Access Compliance Report

Public Rights-of-Way

(Curb Ramps)

Intersection ID: 9099	Main Street: DEWOLFE_ST	Cross Street: JOYCETON_ST	Location: NE
ADA ID: 040A25A9C7E6	Ramp Type: Perp	Initial Pass/Fail: Fail	Overall Compliance: No
		Severity Score: 1.25

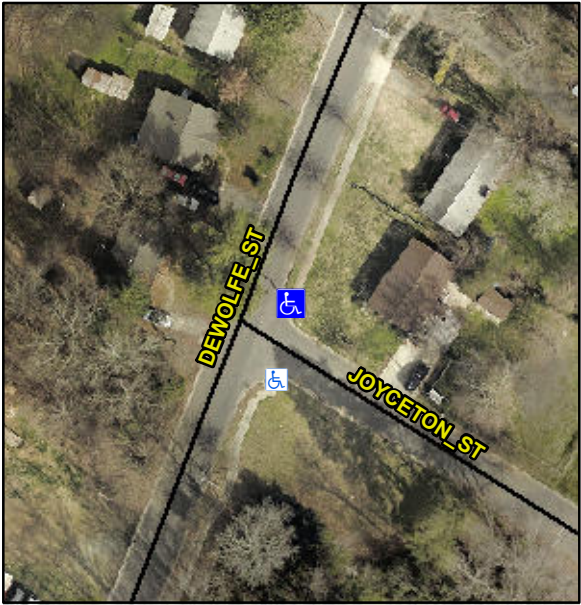
Codes/Mitigation Info/Possible Solution			Field Measurements/Component Compliance		
	Possible Solutions:		Compliance	Description	Data
	Remove & Replace Entire Ramp.		Yes	Ramp Length (in)	47.0
			No	Ramp Width (in)	48.0
			N/A	Flare Type LT	N/A
			N/A	Flare Slope LT (%)	N/A
			N/A	Flare Traversable LT?	N/A
			N/A	Landing Length (in)	N/A
			N/A	Landing Width (in)	N/A
			N/A	Landing Slope (%)	N/A
			N/A	Landing X Slope (%)	N/A
Surveyor Notes: N/A			N/A	Landing Curb? (Y/N)	N/A
			N/A	Shared Landing?	N/A
			N/A	Gutter Ponding?	N/A
			N/A	Gutter Lip Ht (in)	0.5
			No	Painted X Walk1?	N/A
				X Walk 1 Direction	To SW
			N/A	X Walk 1 Width (in)	N/A
				X Walk 1 Slope (%)	5.0
				X Walk 1 X Slope (%)	1.0
			N/A	Ramp inside XWalk1?	N/A
PROW/ADA: Not Found, R304.5.3			N/A	Road Slope (%)	N/A
			N/A	Road X Slope (%)	N/A
			N/A	Any Obstructions?	N/A
				Obstruction Type	
			N/A		
			N/A		
			N/A		
			N/A		
			N/A		
			N/A		
Street 1 Name Stop Condition-Street 2 Street 2 Name Stop Condition-Street 1			N/A	Clear Space?	N/A

N/A	Clear Space to XWalk (in)	N/A
			N/A	Storm Grate/Utility Hazard?	N/A
				Storm Grate/Utility Type	
			N/A		
			N/A		
			N/A		
			N/A		
			N/A		
			N/A		
Total Cost: \$ 1850.00			Yes	Surface Condition? (G/P)	Good
